**FINAL  
MY1 (2022) MONITORING REPORT**

**LAUREL SPRINGS STREAM AND WETLAND MITIGATION SITE**

## **Response to DMS Comments – Monitoring Year 1 (2022)**

Laurel Springs Stream and Wetland Mitigation Site

**Table F. As-Built Planted Species and Stems**

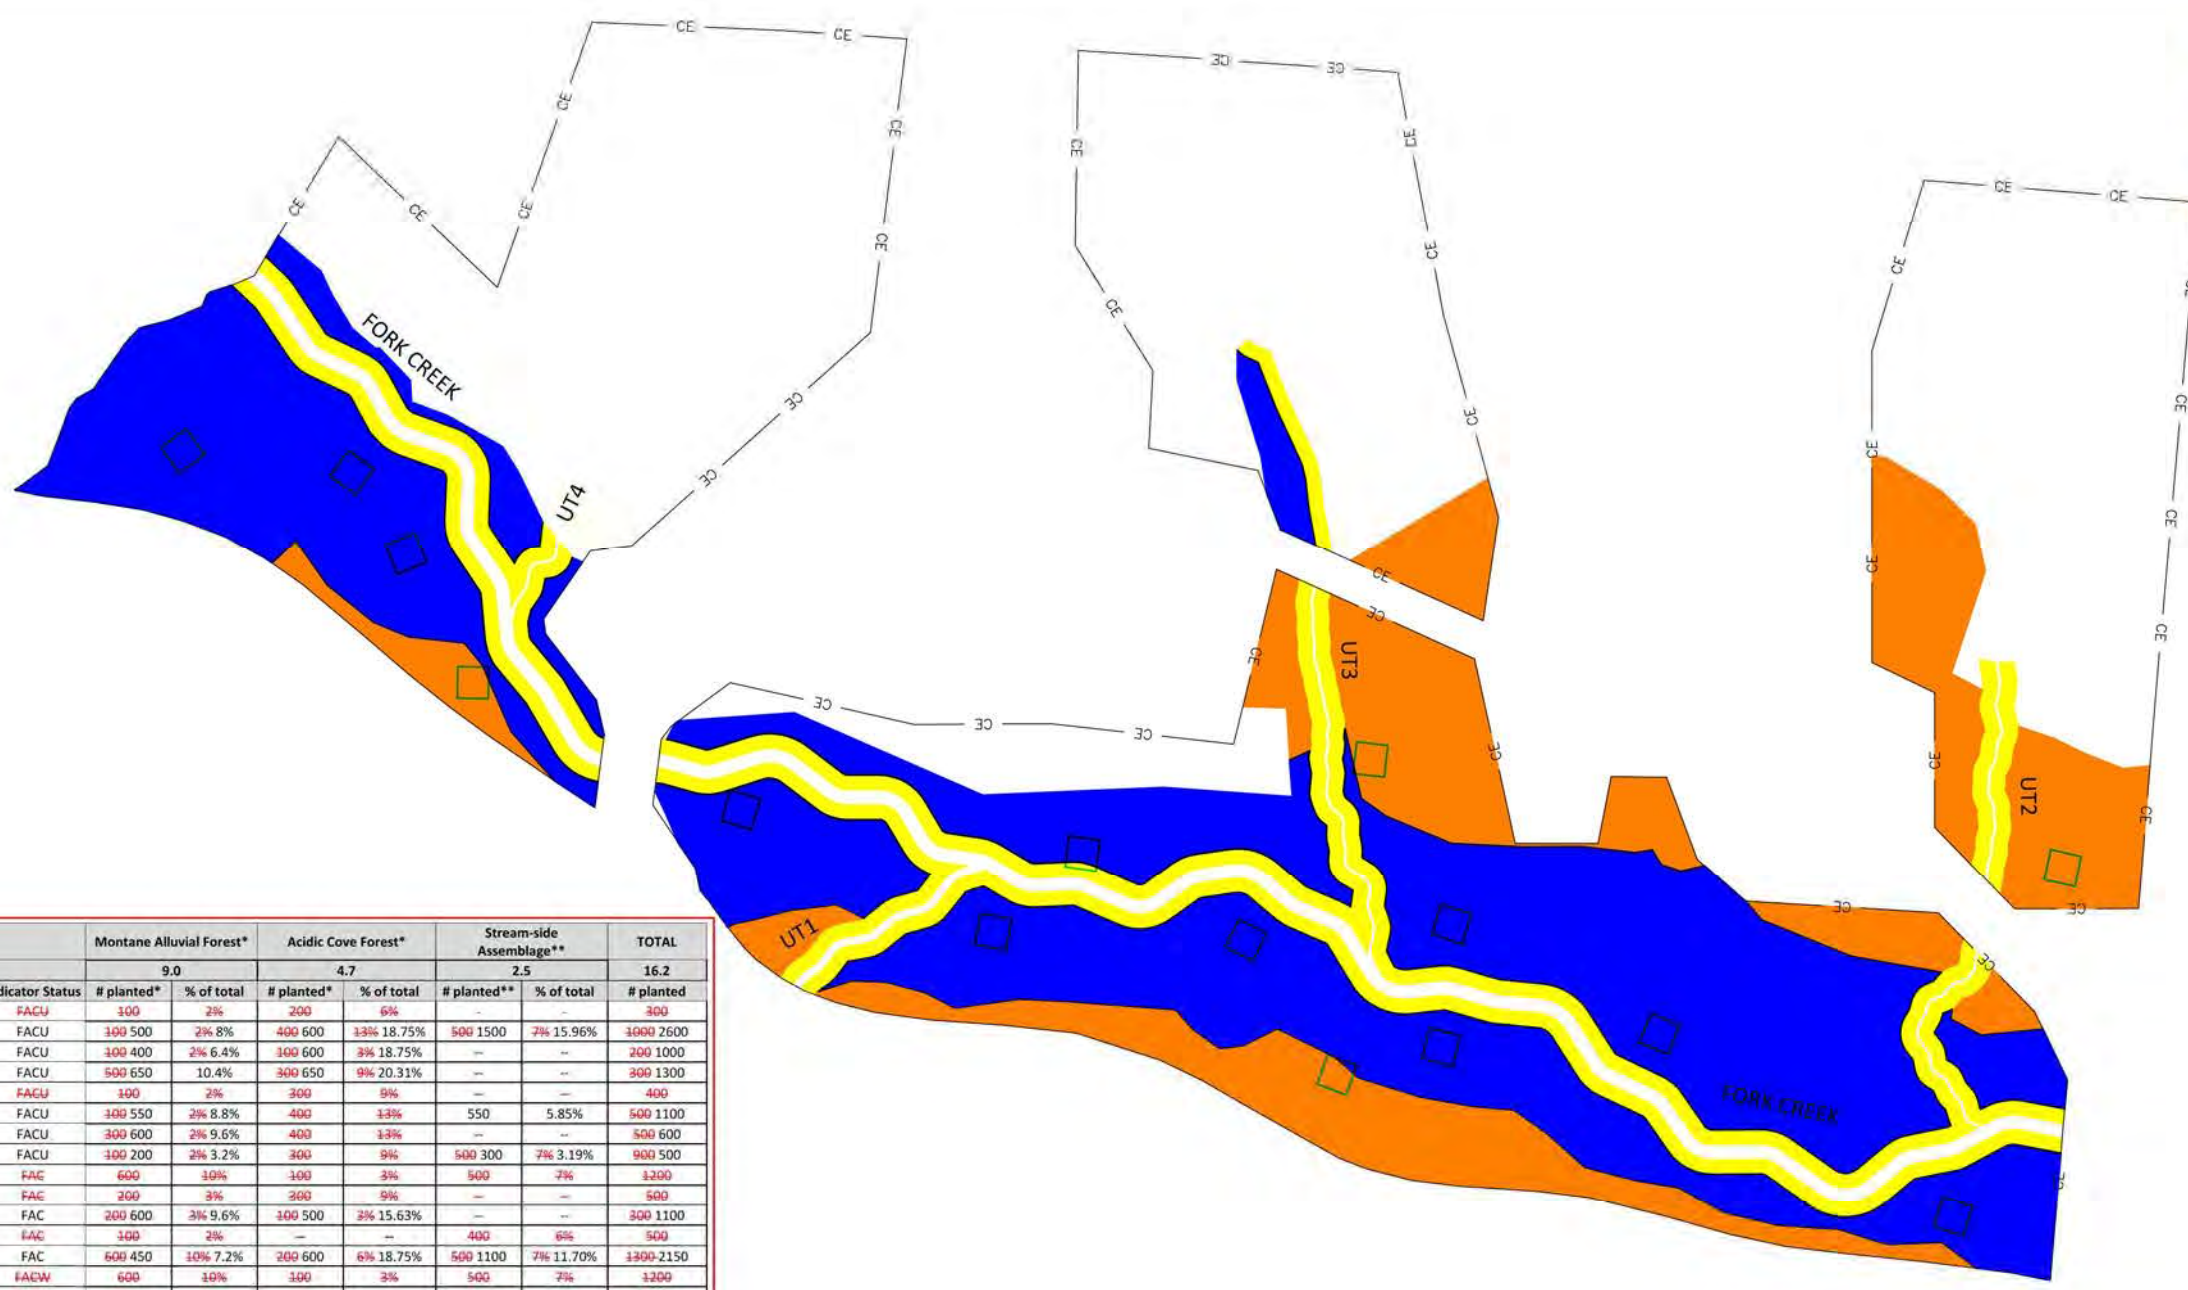
- a. Table A lists yellow birch (*Betula alleghaniensis*) as a species that was not planted; however, Table B shows it was planted but had it listed as swamp birch (*Betula alleghaniensis*). Plan Sheet L5 also indicates it was planted. Please clarify.

- b. Table A should reflect all species that were not planted to include elderberry and buttonbush as shown on Table 18 of the Final Mitigation Plan.

- c. Sheet L5 lists Scarlet Oak as an added species, however this is shown in Table B (and Table 18 in the Mitigation Plan) as an approved species. Table B lists Red Spruce as an added species, whereas Sheet L5 has it listed as an approved species. Please update.

Response: Scarlett oak was planted and was included in the original mitigation plan planting plan; however, the species was incorrectly listed in the mitigation plan as *Quercus imbricaria*. This has been corrected in the redline Recording Drawings planting plan (Sheet L5) and is not considered a species substitution. Red spruce was not included in the mitigation plan. The redline Recording Drawings planting plan (Sheet L5) and Table F (As-Built Planted Species and Stems) of the Baseline Report were updated accordingly.
